G. M. CALHOUN
BRIDGEPORT

MODEL 40X - SERIAL NO. 706
Complaint from Ziniuk & Co.

Re: Capt. Benjamin Naiman, Petch-Tiqva, Israel

FIG 1

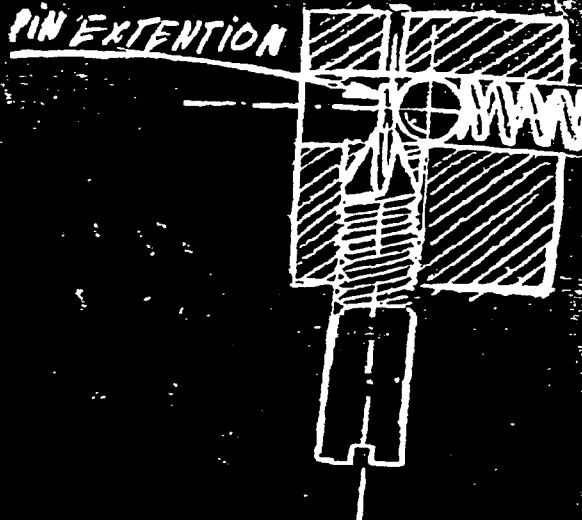
3. Interference Between Receiver & Locking Lug (Fig. 1)

We became aware of this situation incidental to production of first run of rifles and upon investigation it was found that apparently this cut in the receiver was being run with a tool having a radius which was too great and resulted in an interference with the lugs at assembly. In order to compensate for this condition a change was made to open up the diameter of the cut and the radius, which eliminated the interference at assembly.
